SUBJECT: SUMMARY OF JUNE 8, 2000, MEETING WITH COMMONWEALTH EDISON COMPANY TO DISCUSS THE DESIGN OF PIPE SUPPORTS AT LASALLE COUNTY STATION, UNITS 1 AND 2

LaSalle County Station, Units 1 & 2
Presentation to the NRC

Resolution of
Pipe Support Analysis Issues

FEM Beam Elements - First Support (MO9 RH04-2883S)

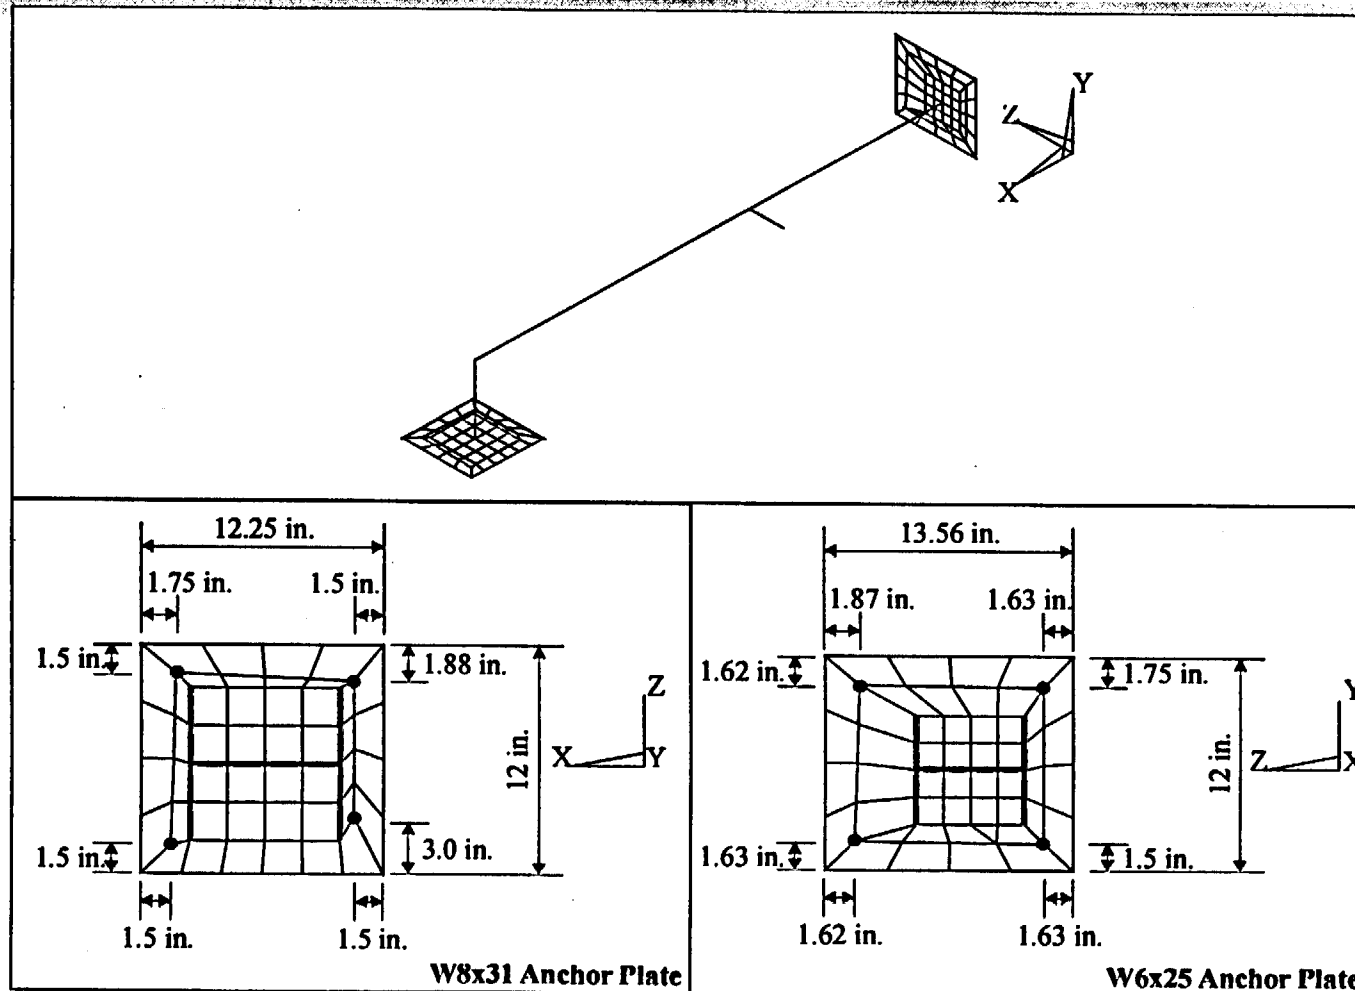
- ❑ Given a support with Concrete Expansion Anchors (CEA's) at maximum design load, the support loads can be increased by a factor of 4 before the CEA ultimate capacity is reached.
- ❑ This was demonstrated in the 1979 ComEd submittal for IEB 79-02.
- ❑ New analyses have revalidated this finding for two highly stressed supports selected by the NRC.

First Support	Second Support
Design Basis Interaction Ratio	0.96	0.8
Safety Factor at Ultimate Capacity	4	5.5

Anchor Bolt Load-Displacement Curves (Showing Secant Moduli)

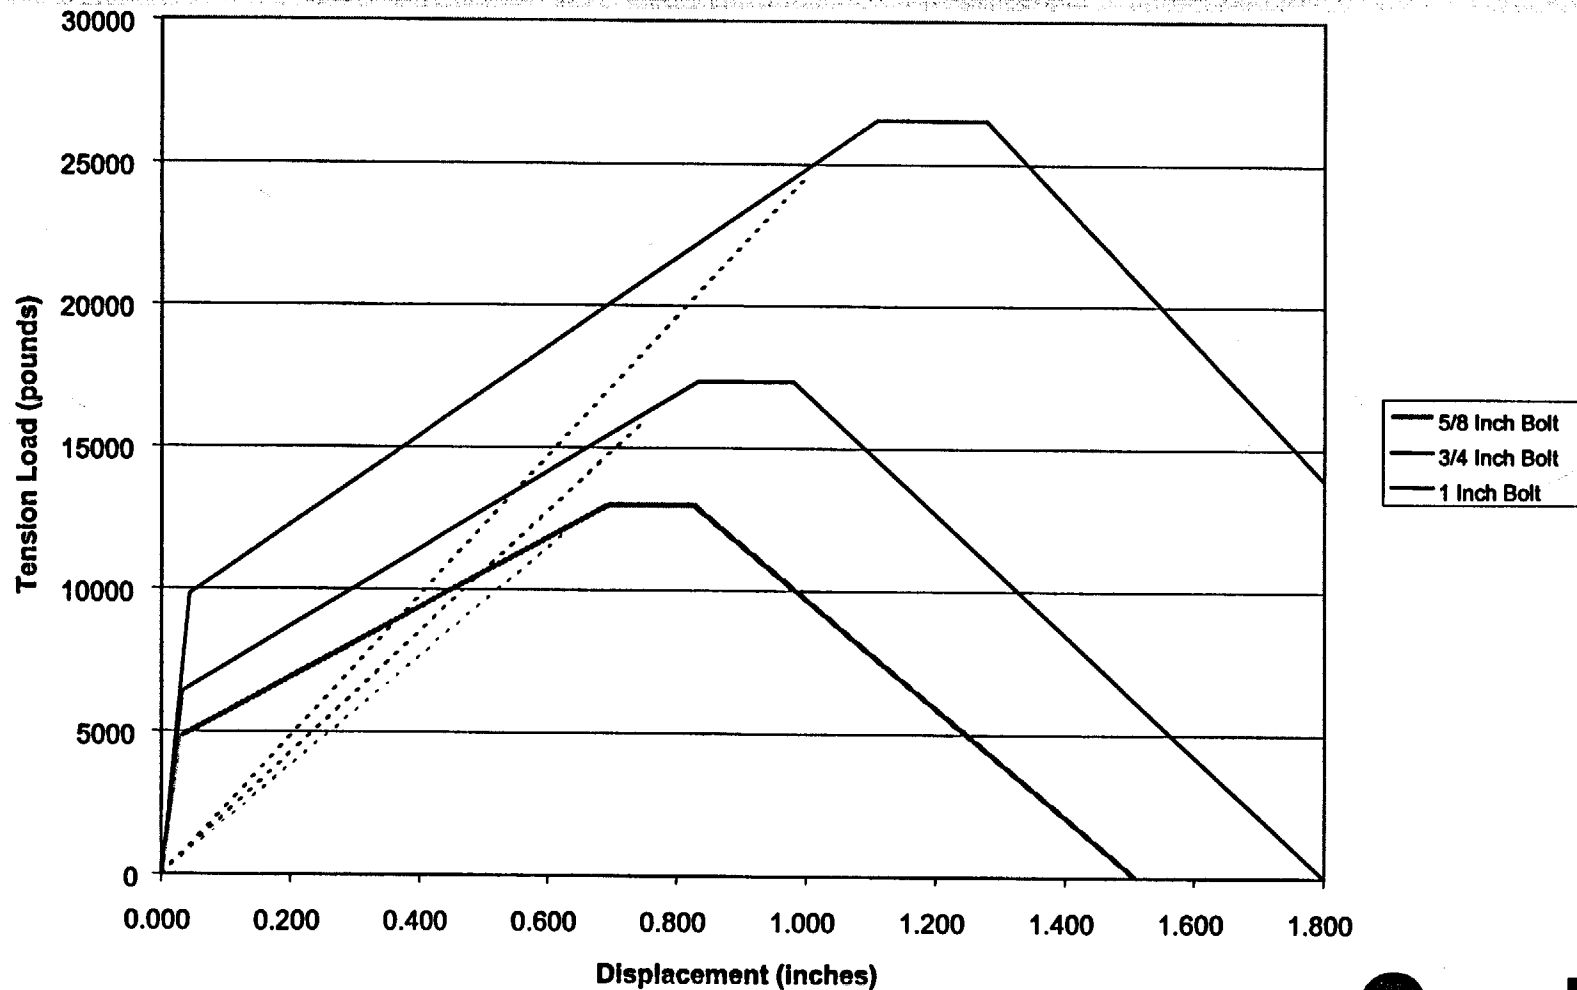
□ 79-02 Margin Guidance- Licensee Action #2

- ❖ “Verify that the concrete expansion anchor bolts have the following minimum factor of safety...a. Four - For wedge and sleeve type anchor bolts...The Bulletin factors of safety were intended for the maximum support load including the SSE...”

ComEd's Demonstrated Margin

- ❖ Given a support with the anchor at maximum design load, the support loads can be increased by more than a factor of 4 before the anchor ultimate capacity is reached.

2-Step Bounding vs. 1-Step Comparison of Results

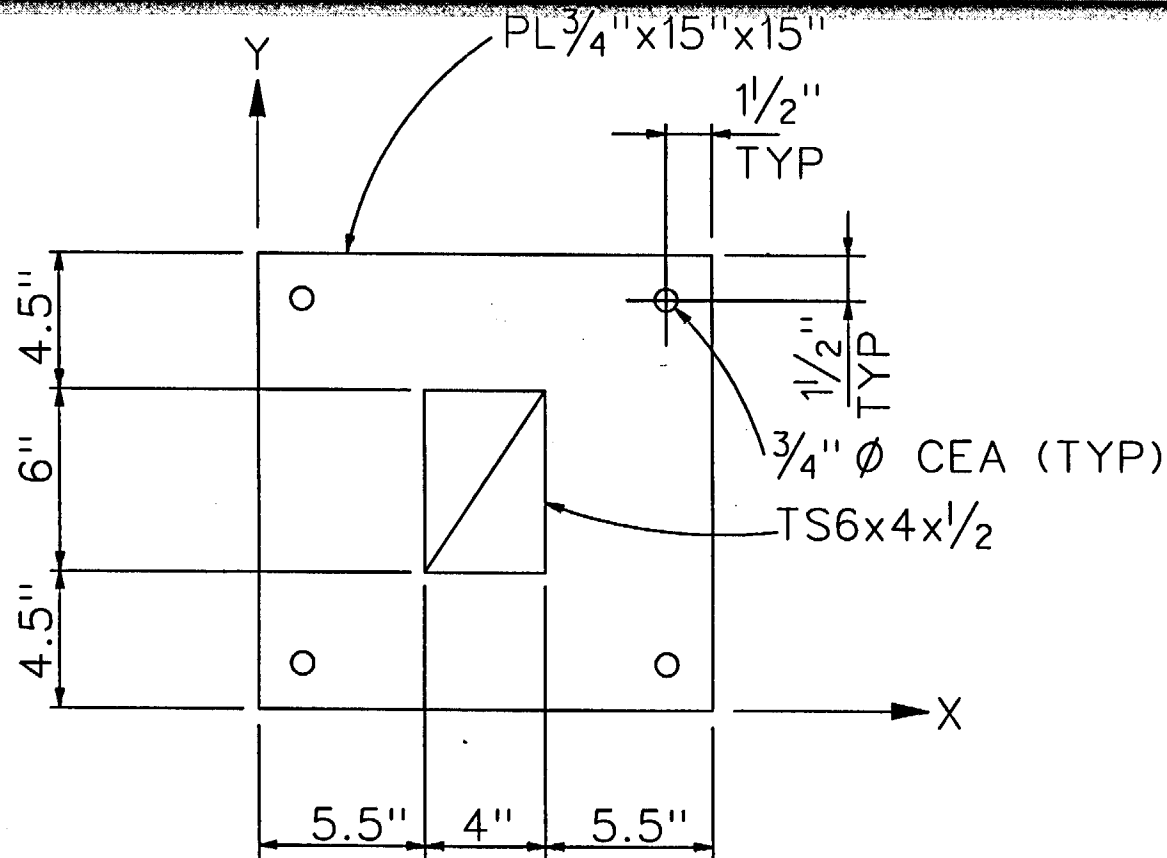
- ❑ 1-Step Analysis of the same two pipe supports was performed using inputs that are consistent with the previous “2-Step bounding” analysis
- ❑ The anchor bolt loads at Node 6 (first support) and Node 1 (second support) were compared
- ❑ Results show that the “2-Step bounding” loads are greater than the 1-Step method
- ❑ Through iteration, the 2-Step method approaches the 1-Step method

First Support M09-RH04-2883S	Second Support M09-LP28-2804X
“2-step bounding” approach	1.825 kips	3.47 kips
1-step approach	1.159 kips	0.89 kips
Ratio of 2-Step/1- Step	1.5	3.8
